MEMORANDUM

PLANNING COMMISSION MEETING

Agenda Planning Commission

City of Decatur, AL

CERTIFICATE TO SUBDIVIDE AND CONSOLIDATE NO.3327-16

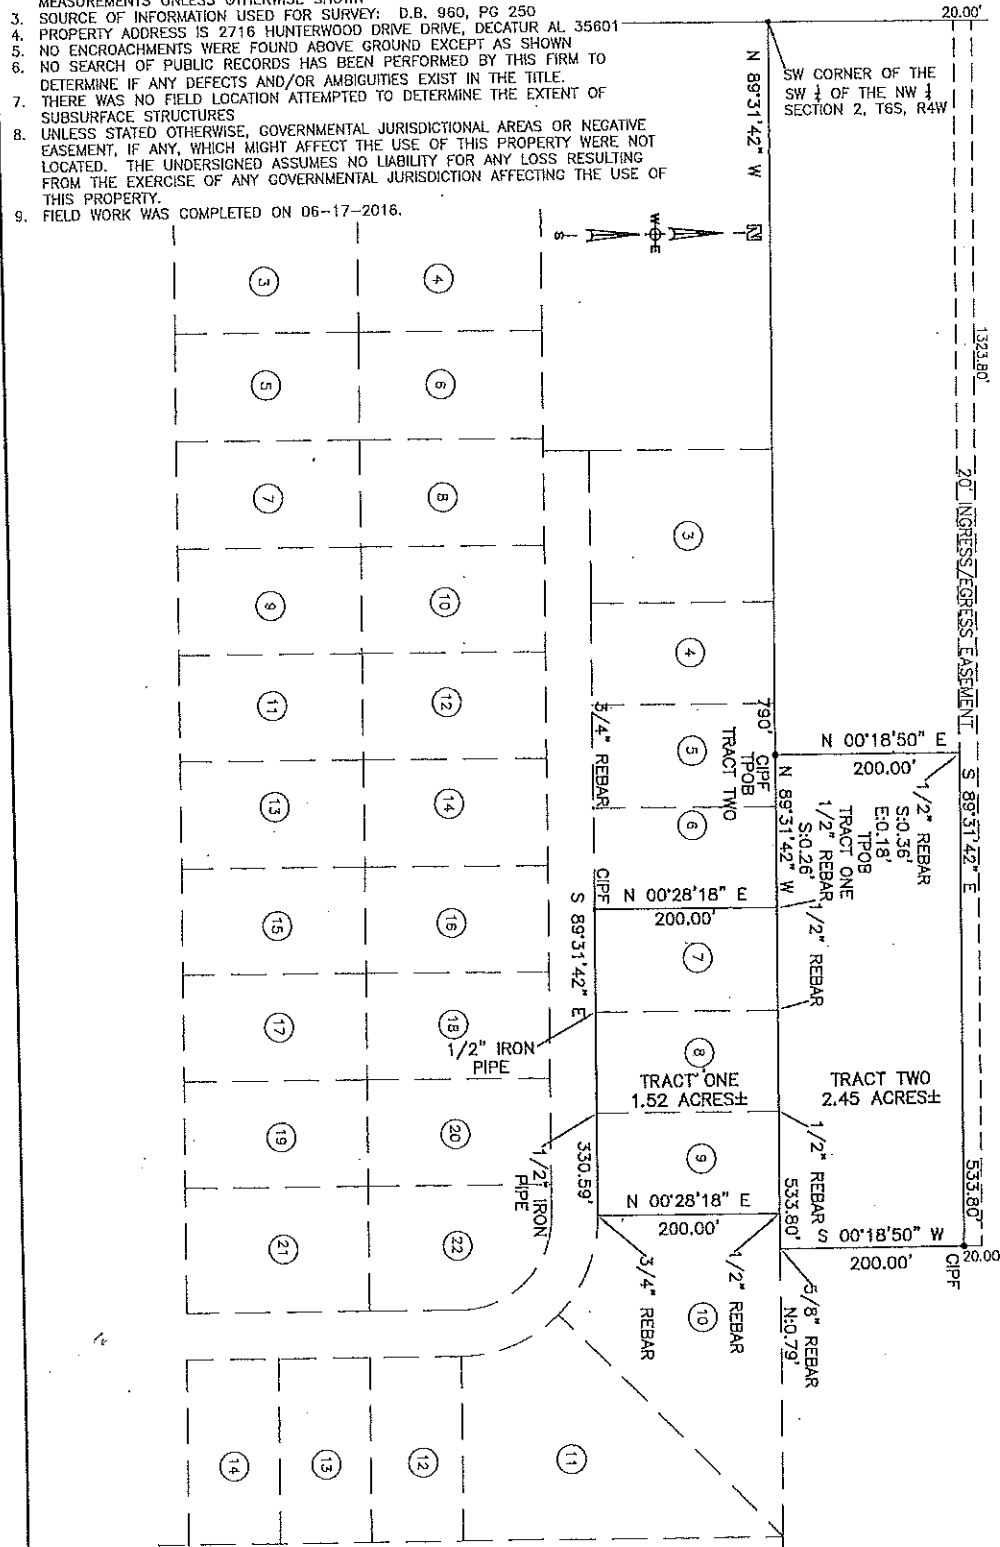
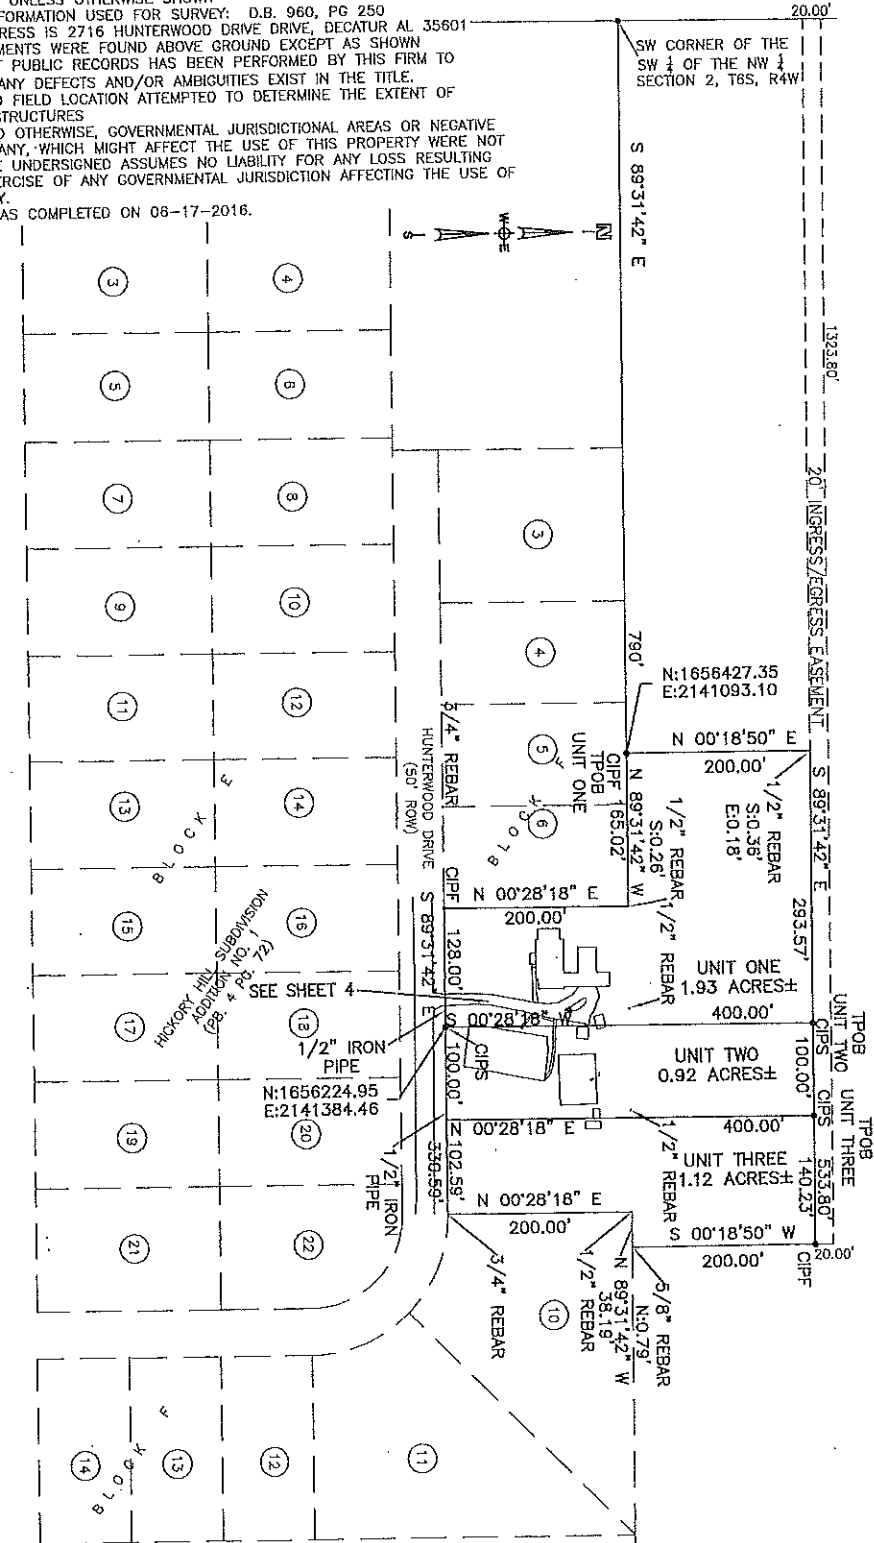
- Conds: 1. Verify/obtain septic tank approvals for all three tracts
 2. Provide a stamped and sealed survey for recording
 3. Payment of recording fees
 4. Provide a letter from property owner requesting subdivision
 5. Provide a copy of the deed showing ownership
 6. Amend survey to show existing electrical poles on Units 1 & 3
